#### Remarks:

# PATENT Attorney Docket No. A34093 PCT USA

FIG. 5

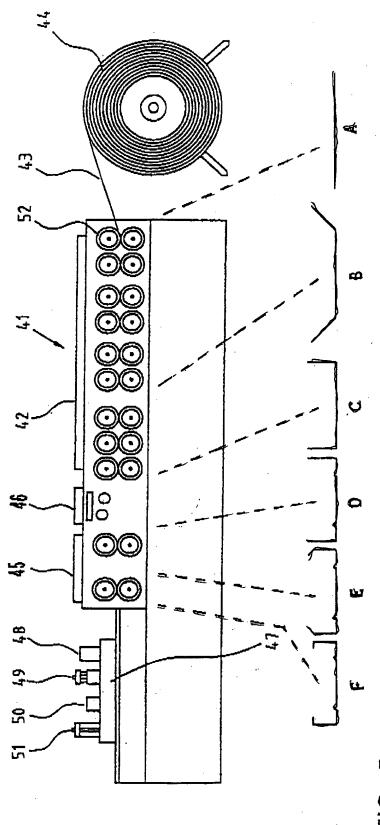
The drawings stand objected to as allegedly failing to show a roll forming apparatus which forms U-section and C-section channel profiles simultaneously on the same sheet as described in the specification. As set forth above with respect to the enablement rejections, in view of the foregoing description of Applicant's invention, Applicant maintains that those of ordinary skill in the art readily may use well known construction techniques to manufacture rollers to produce the U-section profile and the C-section profile. Moreover, Applicant's claimed invention is directed towards a method of construction and is not directed towards the roll forming apparatus. Nevertheless, solely to better clarify the claimed invention, Applicant has amending original **Fig. 5** to depict the progressive change in profile of the steel sheet as it moves through the roll forming apparatus. Therefore, Applicant respectfully requests that the Examiner withdraw the objection to the drawings.

- 1. Unannotated copy of replacement sheet for Fig. 5
- 2. Marked-up copy of replacement sheet for Fig. 5
